PlanGrid Task Report - Oct 2, 2024

L04810_Expressway Plaza FSU

2280 North Ocean Avenue, Farmingville, New York

#90 [UNIT 504] [NEW] Equipment Fresh Air Tempering.

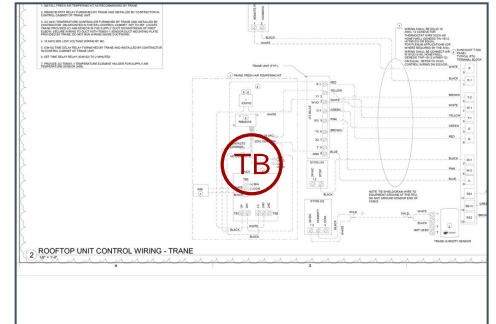
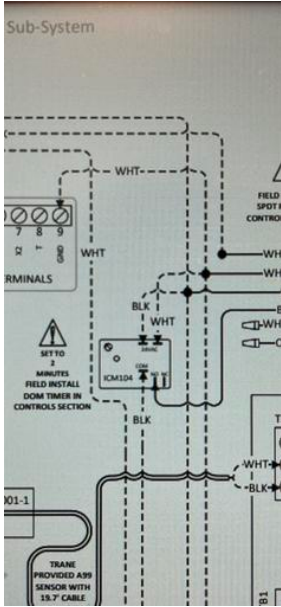
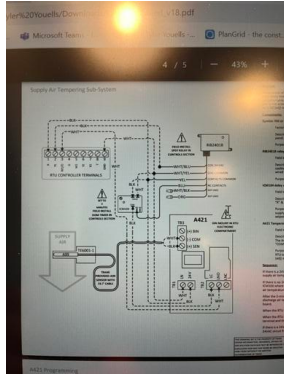
FAT Tempering kits are not functioning properly. The wiring was installed per the Trane drawings provided which also does not match the MSET. When rewired to the MSET drawings the FAT kit still does not work. Per TRANE/SEC MC needs to adapt the kit per the new unreleased spec attached. the new spec requires a different style timer and a few wiring changes.

#89 [EXHA 509] [NEW] Grease exhaust duct is not painted.

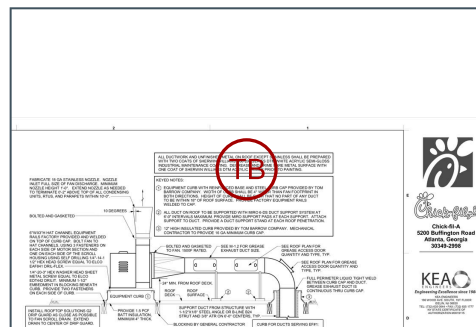
Description
After changes to grease duct repaint/paint ductwork. Exposed grease exhaust duct is to be painted per specification on kitchen hood exhaust fan detail.

#12 [UNIT 514] [NEW] Equipment gas piping.

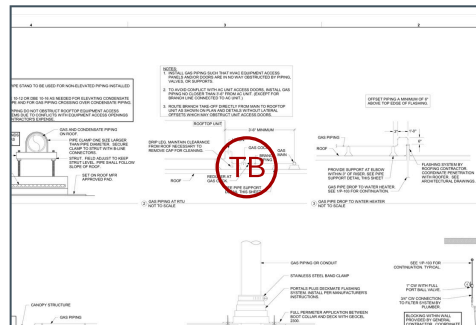
Equipment missing gas grommet, gas startups incomplete, or gas piping is not constructed/supported per normal CFA specifications (incorrect drip leg/missing inverted trap/flex piping connections). Confirm with CFA CM that current installation is acceptable. Typically a reducer occurs pre gas cock. Typical install shown in pics.

#11 [UNIT 517] [NEW] Condensate piping construction.

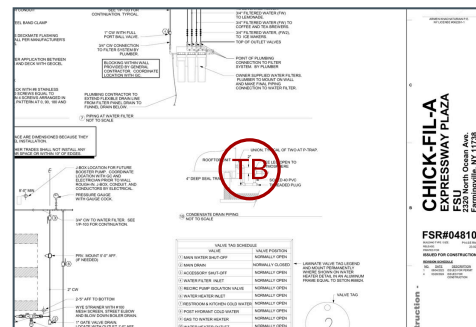
Equipment condensate piping or p-trap is not constructed per normal CFA specifications. Trap does not have a 2" deep seal and open T vent is not cut below outlet of the unit. Correct all ac unit traps.
